Model: Fresa		Date: 31-May-99	No.: RG024001
Subject: Service Manual		Prepared by: H. Someya	
From: Technical Service Dept., GTS Division			
Classification:	<input type="checkbox"/> Troubleshooting	<input type="checkbox"/> Part information	<input type="checkbox"/> Action required
	<input type="checkbox"/> Mechanical	<input type="checkbox"/> Electrical	<input type="checkbox"/> Service manual revision
	<input type="checkbox"/> Paper path	<input type="checkbox"/> Transmit/receive	<input type="checkbox"/> Retrofit information
	<input checked="" type="checkbox"/> Other ()

Model: Fresa		Date: 30-Jun-99	No.: RG024002
Subject: Service Manual		Prepared by: H. Someya	
From: Technical Service Dept., GTS Division			
Classification:	<input type="checkbox"/> Troubleshooting	<input type="checkbox"/> Part information	<input type="checkbox"/> Action required
	<input type="checkbox"/> Mechanical	<input type="checkbox"/> Electrical	<input checked="" type="checkbox"/> Service manual revision
	<input type="checkbox"/> Paper path	<input type="checkbox"/> Transmit/receive	<input type="checkbox"/> Retrofit information
	<input type="checkbox"/> Other ()

Please correct your service manual as follows.

Page 2-6 PCU Overview

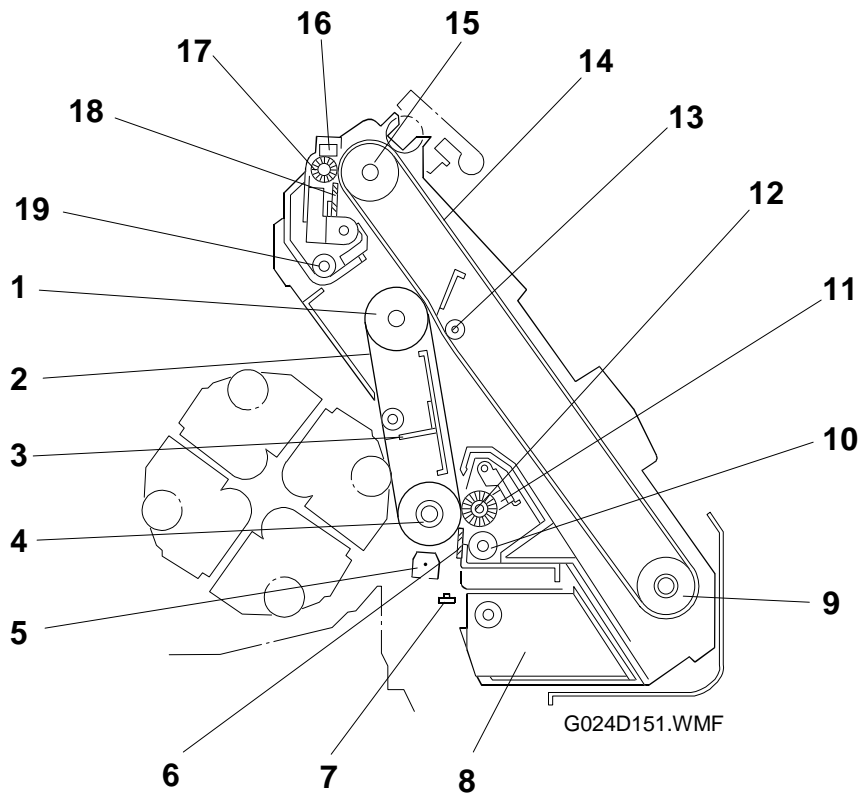
The callouts in the illustration below must be corrected.

Page 2-32 Development Unit Drive

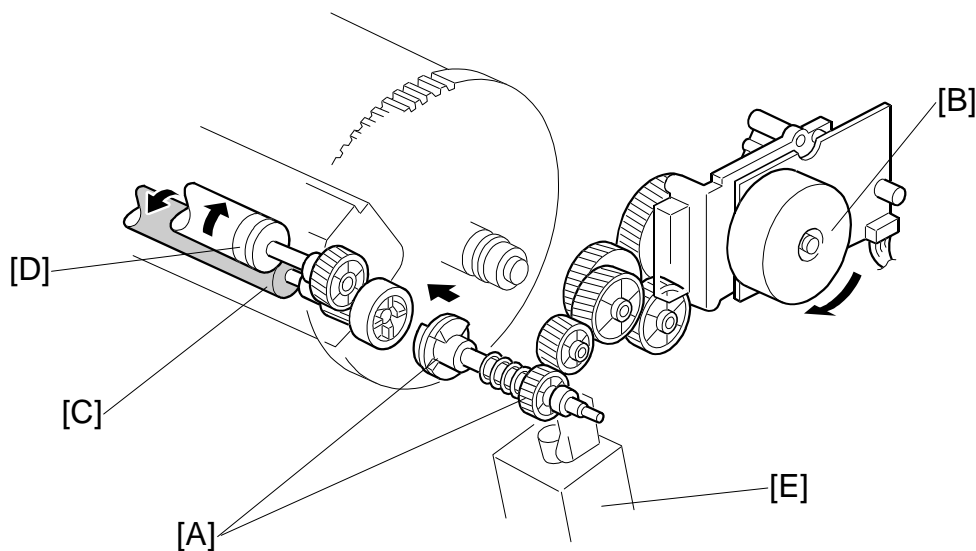
The callout [A] should be added to the gear.

Page 2-36 DTM (Development Toner Magazine) Detection

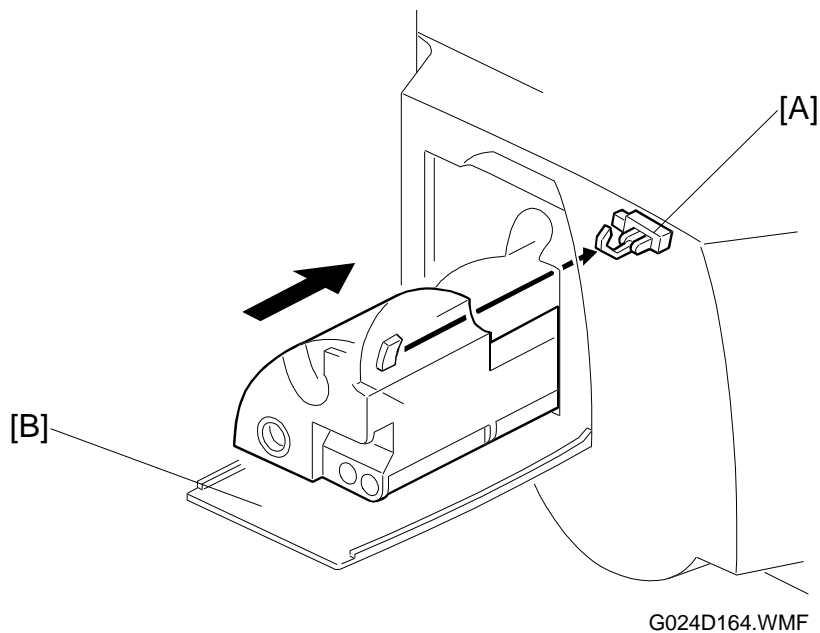
Incorrect

Installing a toner bottle and closing the front cover [B] automatically initiates the recovery procedure, clearing the error.

The callout [B] should be added.

Correct

Installing a toner bottle and closing the **DTM cover** [B] automatically initiates the recovery procedure, clearing the error.

Page 6-3 Bottom Front Cover

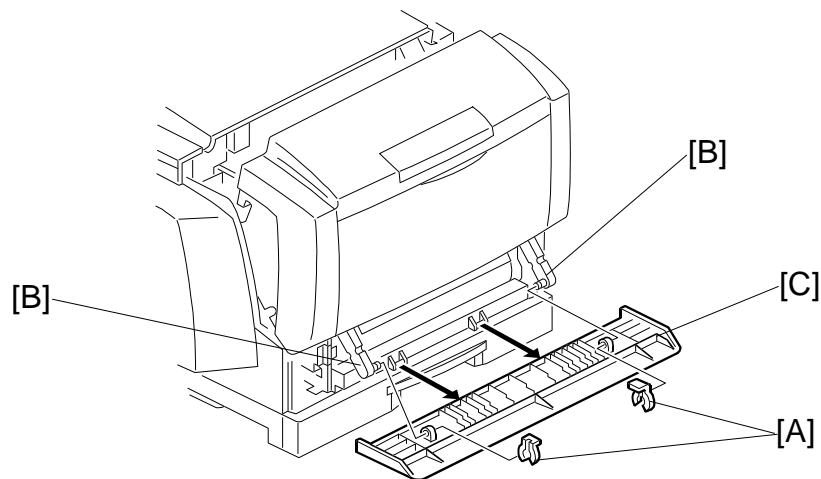
A supplementary explanation should be added to the procedure below.

1. Open the front cover half way, and remove the two snap rings [A].
2. Carefully slide the hinge levers [B] out from the bottom front cover [C]. The levers are spring loaded.
3. Remove the bottom front cover.

Page 6-3 Front Cover and Operation Panel

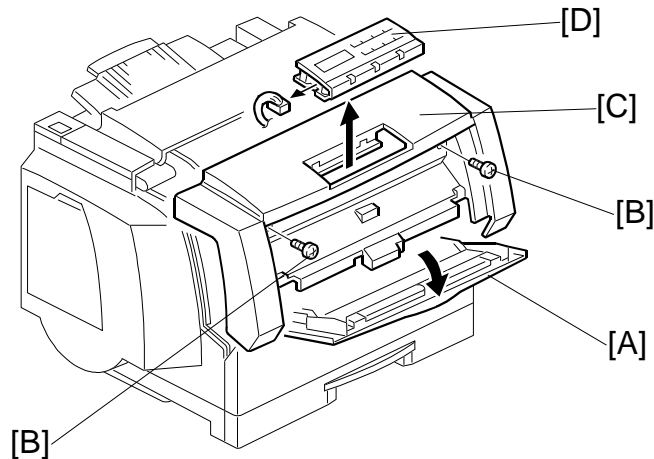
A supplementary explanation should be added to the procedure below.

1. Open the by-pass tray [A].
2. Remove the two screws [B] and carefully lift the front cover [C] from the printer.
3. Remove the operation panel [D] from the front cover (two hooks). Be sure to unplug the connector from the operation panel.

NOTE: The surface of the operation panel circuit board is not insulated. When turning on the printer while the operation panel is being removed from the front cover, exercise extra caution in order to prevent a short circuit of the board.

Page 6-18 LD Unit

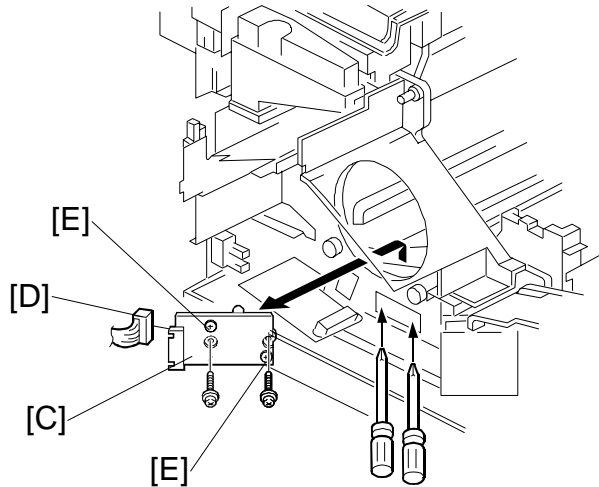
The callouts of the illustration below must be corrected.

Page 6-35 Controller Board, Temperature/Humidity Sensor

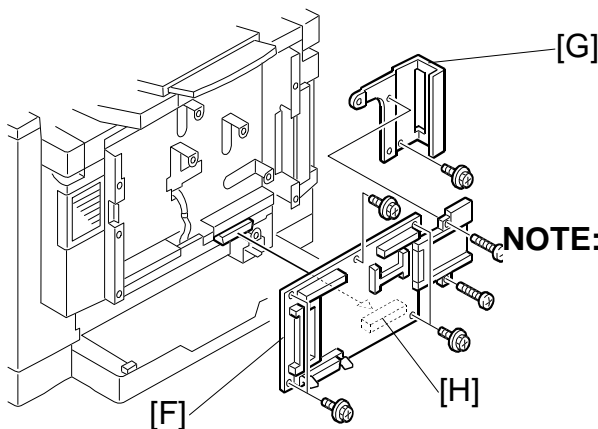
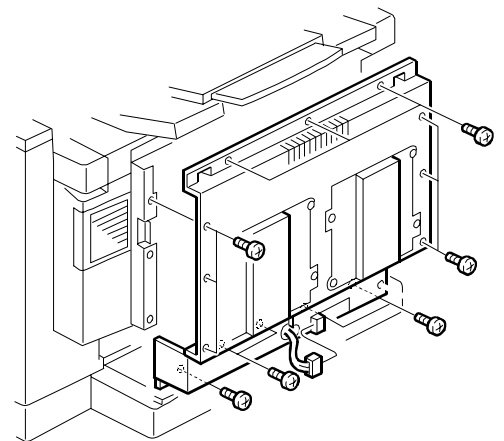
The explanation in step 2 of the procedure and callout [H] should be corrected.

4. Remove the controller cover [E] (16 screws, including 2 screws around the parallel port).
5. Remove the controller board [F] with the bracket [G] attached to it (6 screws, 1 connector [H]).
6. Remove the bracket [G] and 2 screws from the controller board.

NOTE: To replace the controller boards, remove the NVRAM chip (IC23) on the old board, install it on the new board and finally install the new board itself. The NVRAM chip stores user settings and service records. These settings will be lost if the NVRAM chip is not transferred to the new board.

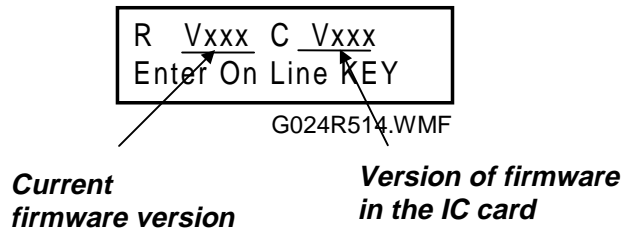
The explanation of the versions displayed during engine firmware updating (section 6.5.5) is switched around.

The version at the left side shows the current version and the other is the one in the IC card.

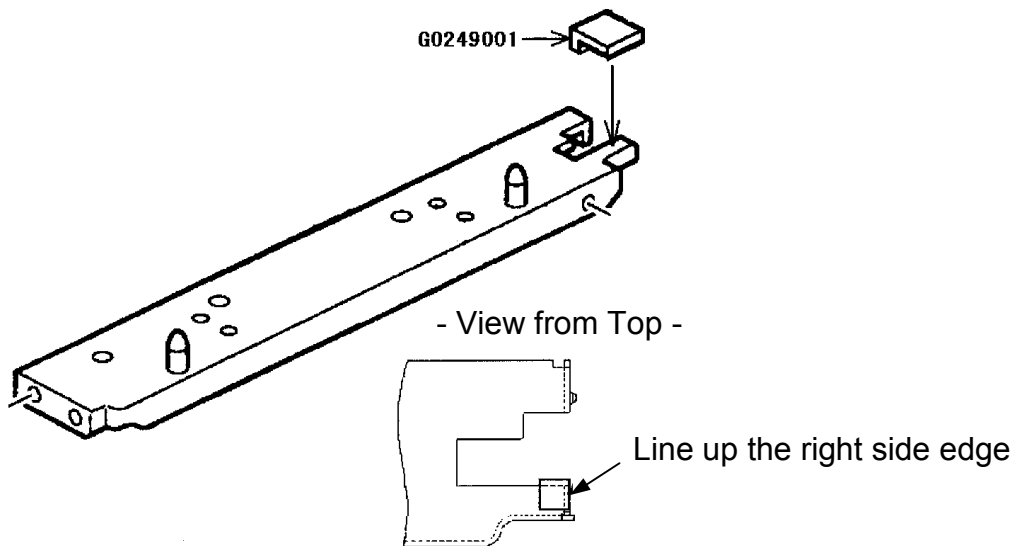
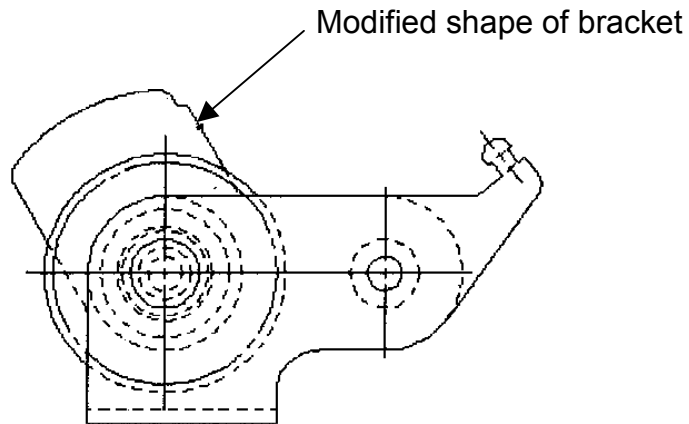
- 1) Acoustic noise from the upper cover around the fusing unit
- 2) Tightner Gear Ass'y (G0241808) damaged. (No fusing unit drive)

The thread engagement between the fusing contact/separation gear and the fusing drive gear is too much.

For the machines produced before January '00,
Put Spacer – Fusing Stay (G0249001) on the Fusing Unit Stay as shown in the illustration below.

The shape of the Tightener Gear Ass'y bracket (which contains the contact/separation gear) was changed to prevent excessive thread engagement between gears.

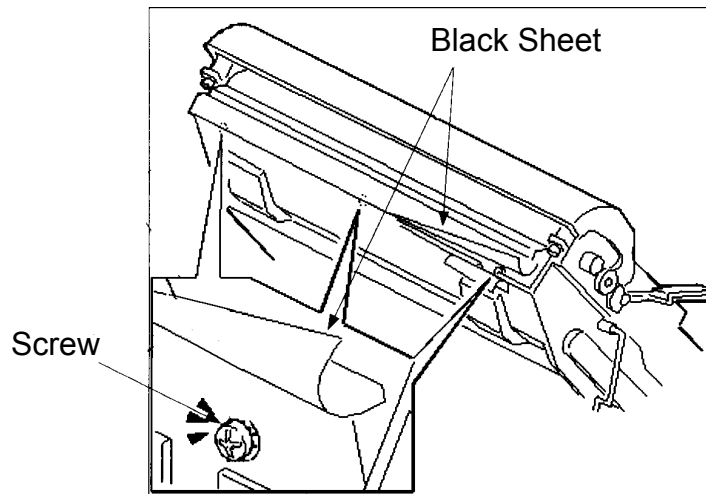
A rattling noise can sometimes be heard from the PCU during printing.

The heat cycle in the machine causes expansion and contraction of the paper transfer cleaning cover. This in turn causes the screws holding the cover to the PCU frame to become loose or fall out. Fallen screws interfere with the rotation of the screening auger.

Secure the cover with the following screws:

This modification was applied to the production line from October 1999.
PCU lot number: 99100001 or later.
